**Re: Request for More Information – NOI  
Landfill Cap Investigation  
46 Broad Street  
Medway, Massachusetts**

On behalf of the Town of Medway Department of Public Works, Weston & Sampson Engineers, Inc. is hereby enclosing the requested responses to the following comments (shown in bold) issued via email on September 2, 2025:

FIGURE 1  
MEDWAY LANDFILL  
MEDWAY, MASSACHUSETTS  
EXISTING CONDITIONS SITE PLAN  
SCALE: 1"=100'

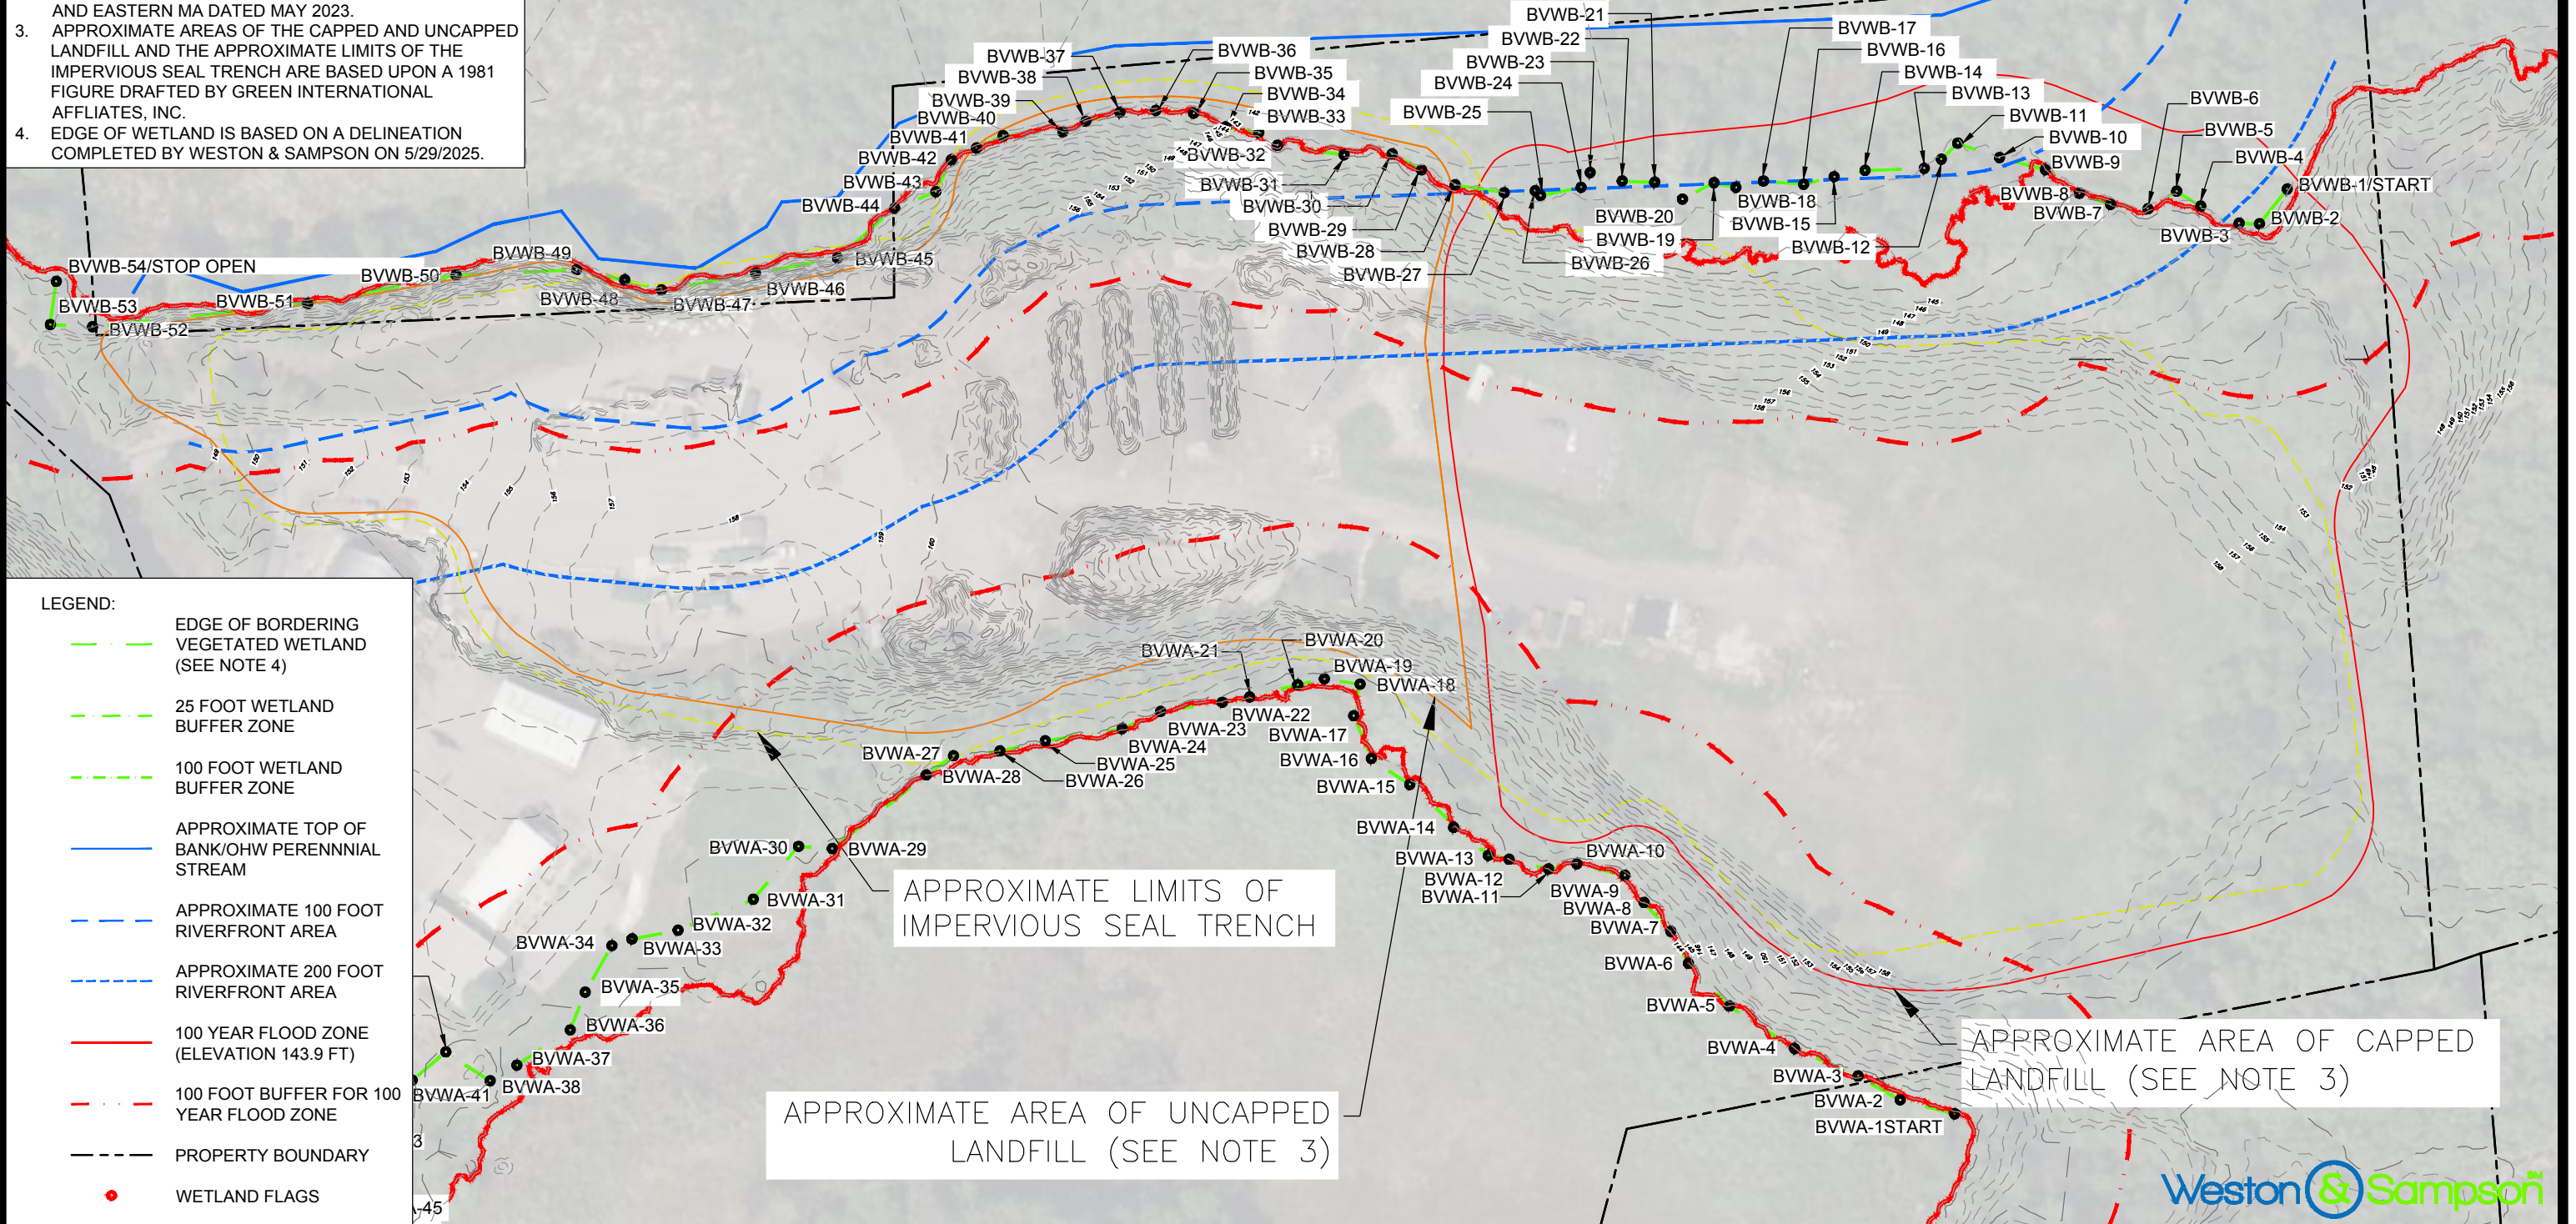
#### 21. Bordering Land Subject to Flooding – topography to be added to the plans, there are no grades on the plans, was this shown as 143.9?

21. W&S Response: The line depicting Bordering Land Subject to Flooding is depicted at elevation 143.9. A figure showing the elevation grades is attached.

FIGURE 5  
MEDWAY LANDFILL  
MEDWAY, MASSACHUSETTS  
EROSION CONTROL DETAILS  
NOT TO SCALE

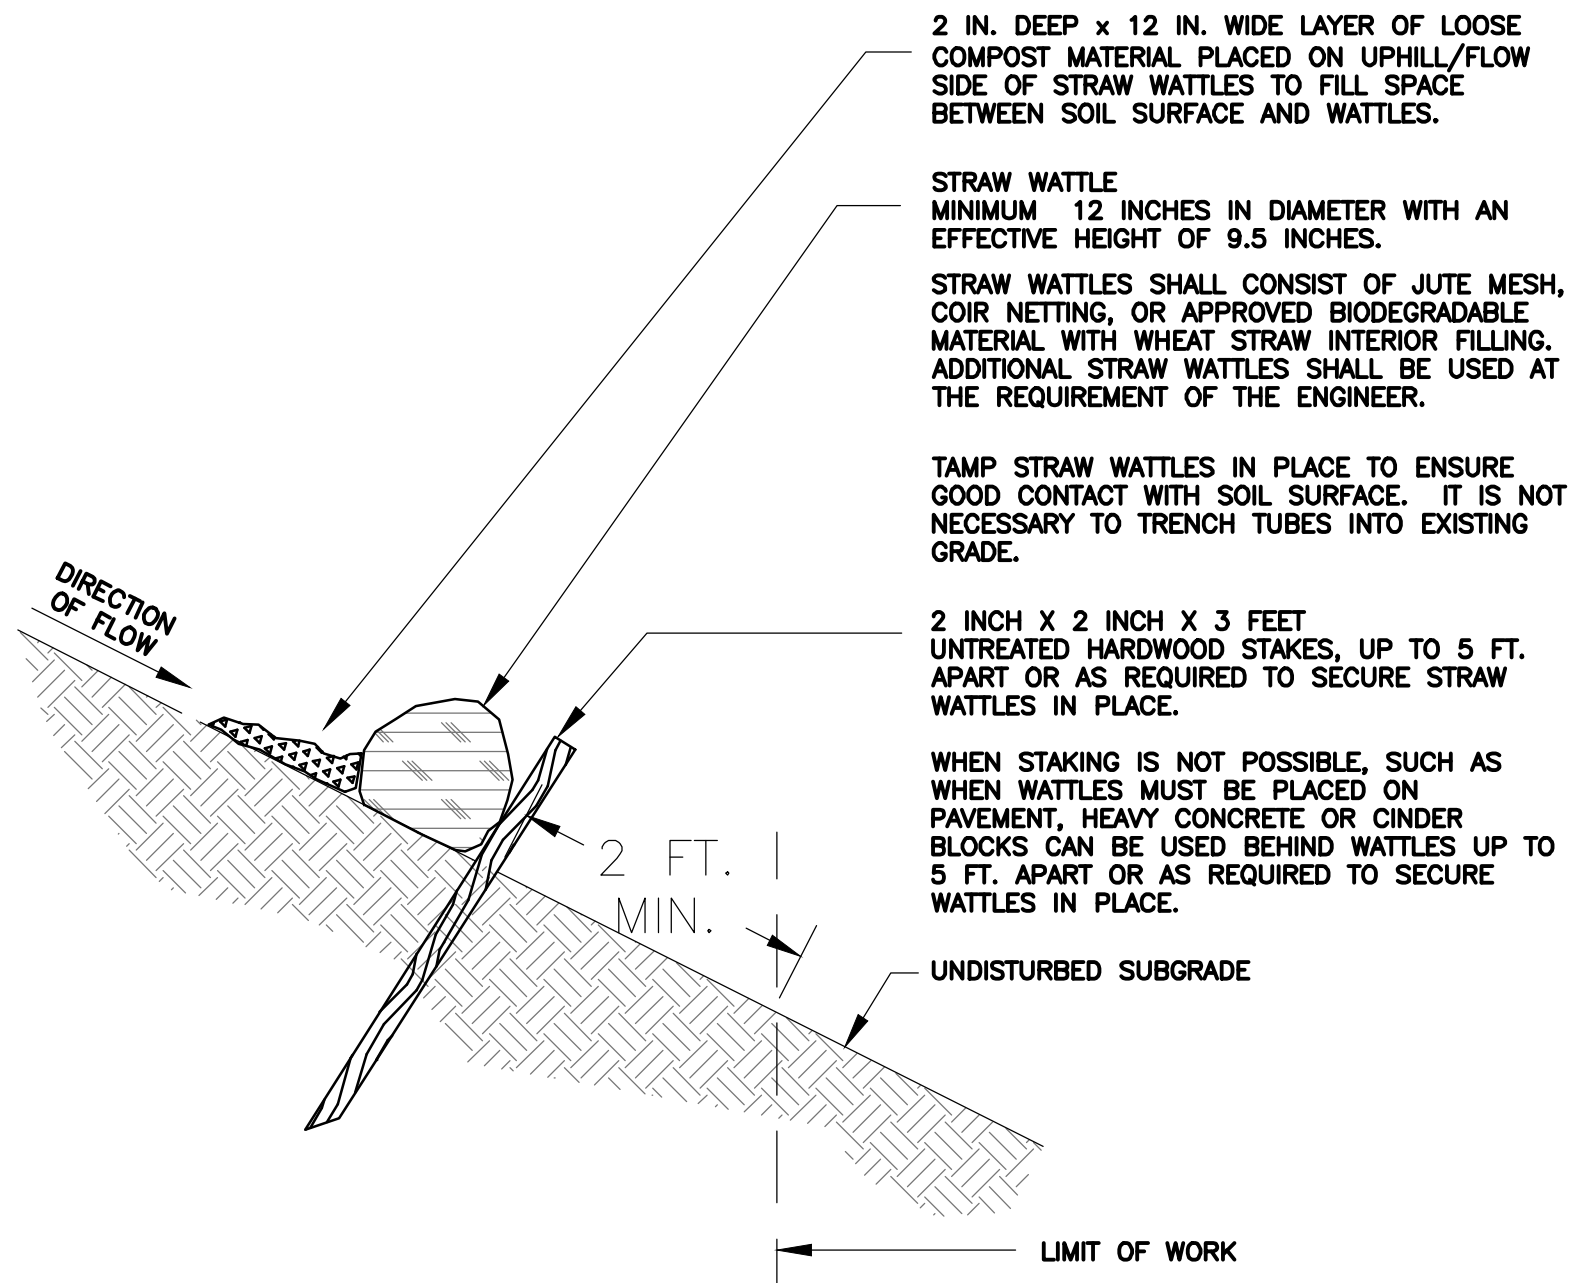
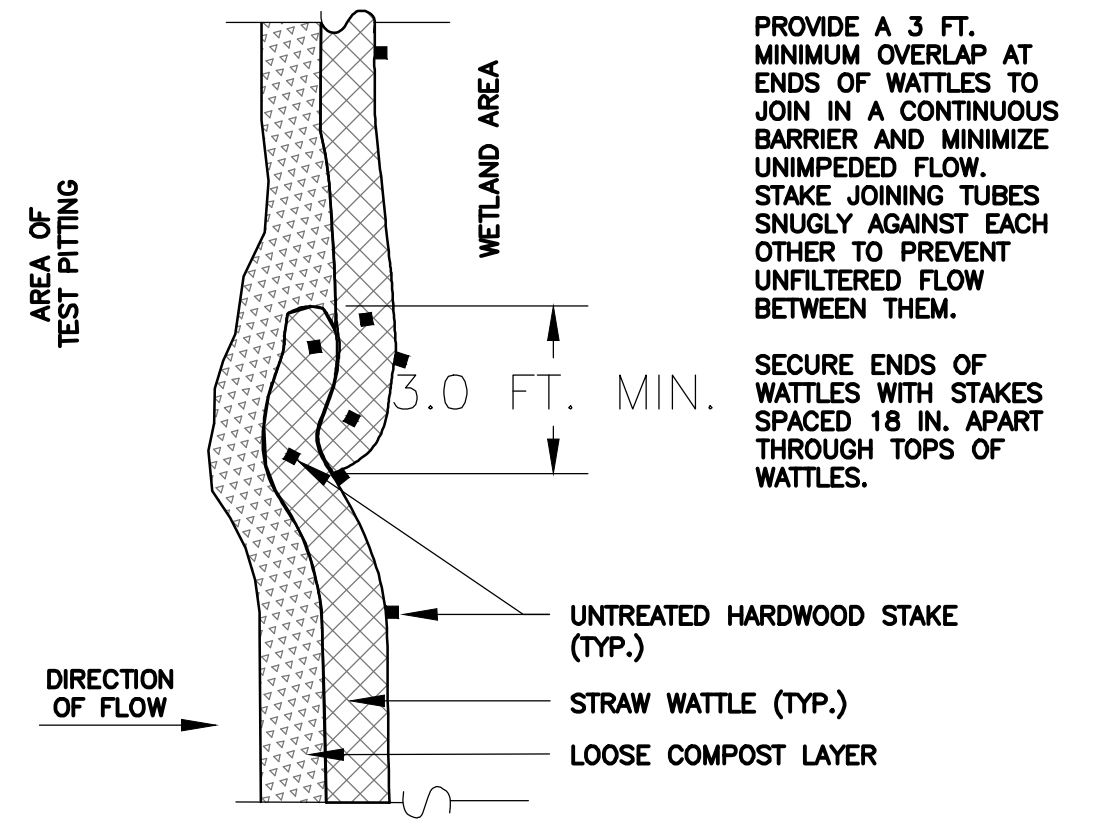
**33. Section 13 (Appendix E) page 01570-4 -notes straw wattles – this is in contradiction to the detail provided**

33. W&S Response: Straw wattles are proposed. A revised Figure 5 – Erosion Control Details is attached.
